Z-84  
(2017)

260 HILLCREST DRIVE  
AUSTELL, GEORGIA

### **Z-84 RANDY E. PIMSLER**

SITE PLAN  
FST 5

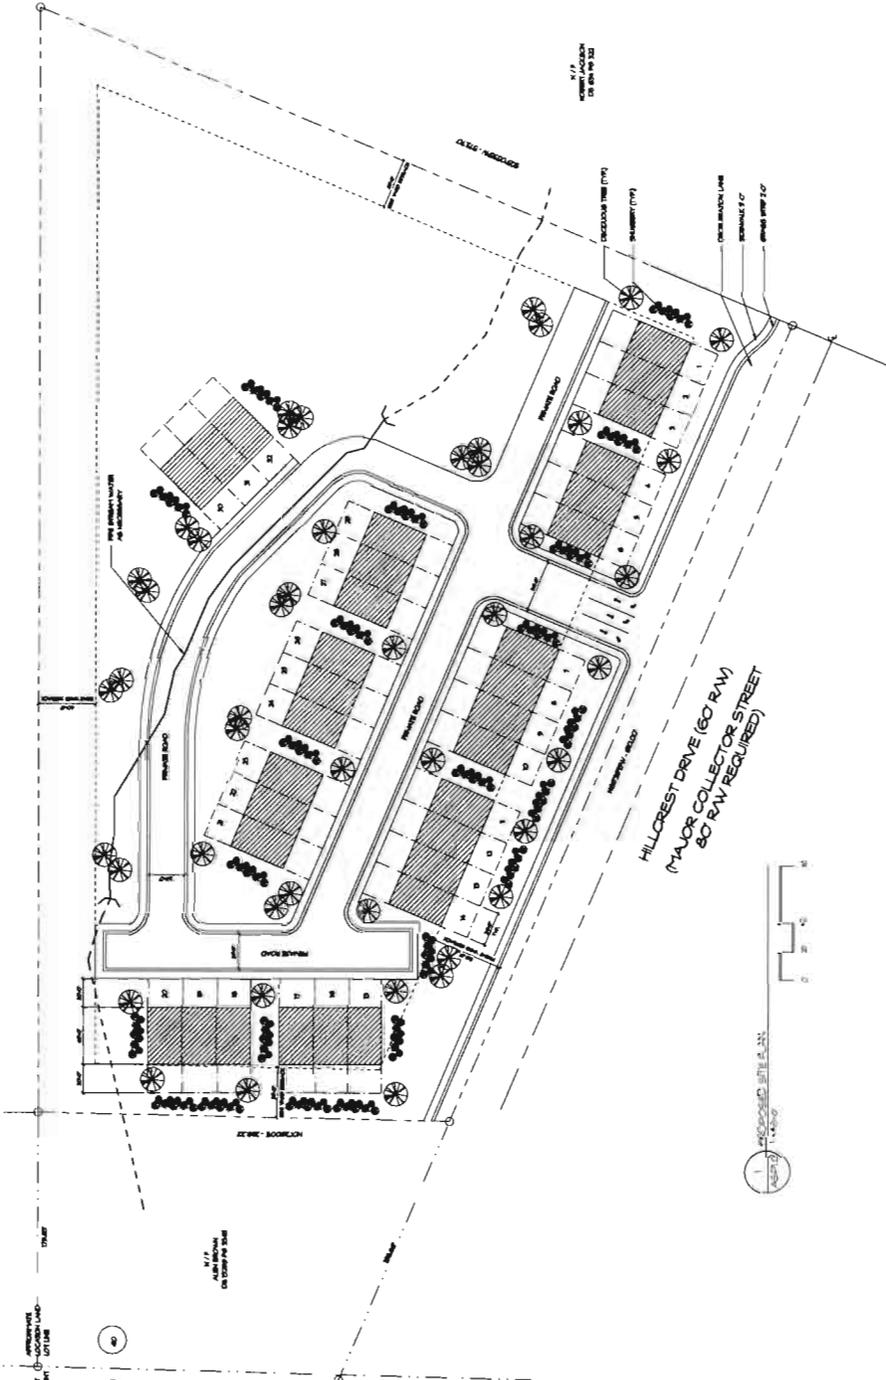
**GUEST PARKING:** Unless a driveway is provided for each unit that is 2 vehicles wide and 20-ft deep as measured from the back of the sidewalk or the back of the curb -where a sidewalk is not present- guest parking is recommended to be at least 1 dedicated parking space for every unit. The current plan dated 10/03/2017 would require an additional 32 guest parking spaces for the 32 units proposed.

- No Stormwater controls shown \_\_\_\_\_
- Copy of survey is not current – Additional comments may be forthcoming when current site conditions are exposed.
- No site improvements showing on exhibit.

1. Site plan received by the Zoning Division on November 6, 2017, with the District Commissioner approving minor modifications;
2. Water and Sewer Division comments and recommendations;
3. Stormwater Management Division comments and recommendations;
4. Department of Transportation comments and recommendations; and
5. Owner/developer to enter into a Development Agreement pursuant to O.C.G.A. §36-71-13 for dedication of system improvements to mitigate traffic concerns.
